Distr.  
GENERAL  
TRANS/WP.29/2003/41  
4 April 2003

PROPOSAL FOR DRAFT SUPPLEMENT 3 TO THE 05 SERIES  
OF AMENDMENTS TO REGULATION No. 83

(Emissions of M<sub>1</sub> and N<sub>1</sub> categories of vehicles)

Transmitted by the Working Party on Pollution and Energy (GRPE)

Condition A of the Type I test

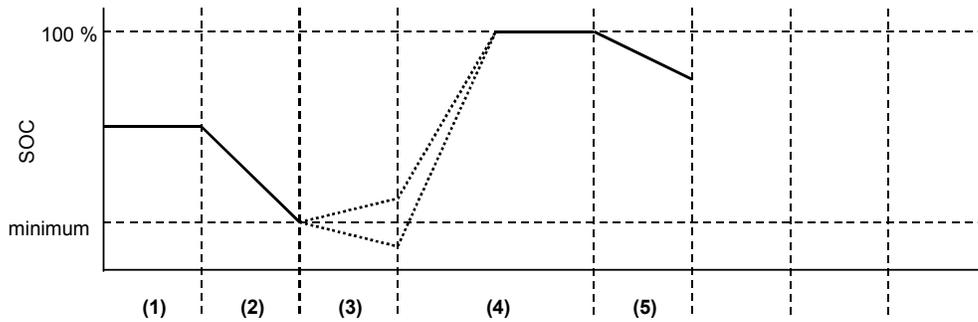
Condition A:

- (1) initial electrical energy/power storage device state of charge
- (2) discharge according to paragraph 3.1.2.1. or 3.2.2.1.
- (3) vehicle conditioning according to paragraph 3.1.2.2. or 3.2.2.2.
- (4) charge during soak according to paragraphs 3.1.2.3. and 3.1.2.4., or paragraphs 3.2.2.3. and 3.2.2.4.
- (5) test according to paragraph 3.1.2.5. or 3.2.2.5.

Condition B of the Type I test

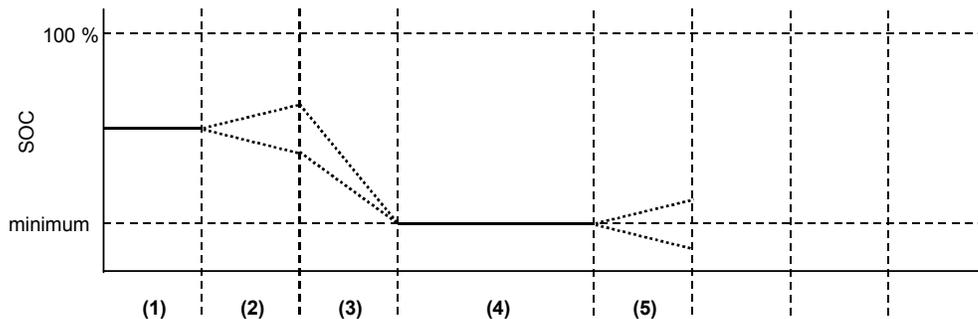
Condition B:

- (1) initial state of charge
- (2) vehicle conditioning according to paragraph 3.1.3.1. or 3.2.3.1.
- (3) discharge according to paragraph 3.1.3.2. or 3.2.3.2.
- (4) soak according to paragraph 3.1.3.3. or 3.2.3.3.
- (5) test according to paragraph 3.1.3.4. or 3.2.3.4.
